LAA/AWA/20/24
9th December 2020

Volkswagen Engines Removal of Mechanical Fuel Pumps Using Plastic Rocker Arms from Service

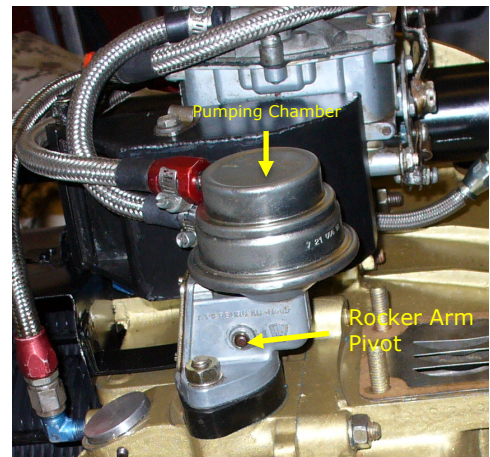
Enquiries suggest that 'after-market' pumps using plastic rocker arms have a high failure rate and, for little extra cost, pumps based upon the original VW design, using steel rocker arms, are readily available. For this reason, mechanical fuel pumps using plastic rocker arms must not be used on VW derived aero-engines operating under an LAA administered Permit to Fly.

This picture (above) shows a fairly typical after-market automotive mechanical fuel pump. Note that the chamber containing the diaphragm and non-return valves is a sealed unit but, in this example, because a side panel may be removable to inspect the rocker arm itself, it may not be necessary to lift the pump itself. OEM pumps can be stripped into individual components.

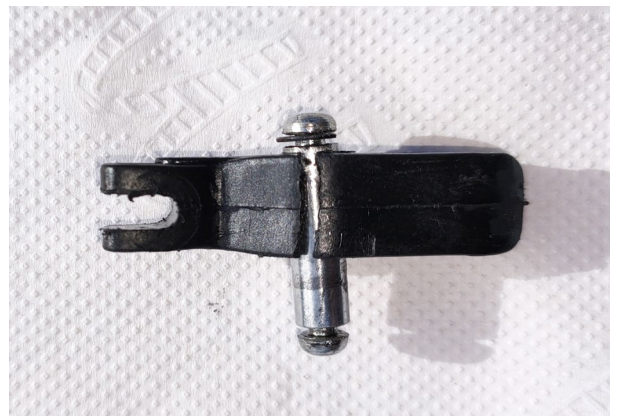
A recent engine failure affecting a Druine D.31 Turbulent aircraft led to an off-airfield forced landing, during which the aircraft was substantially damaged; fortunately, the pilot wasn't seriously hurt in the incident. After a detailed examination of the engine, the LAA Inspector discovered that the rocker arm, designed to transfer motive force from the engine's mechanical fuel pump operating pushrod to the fuel pump's diaphragm, had broken at its pivot, preventing the pump from operating.

The picture above shows the rocker arm from the failed fuel pump described in the text. Following the recent accident, plastic rocker arms are not considered suitable for use in an aero application.
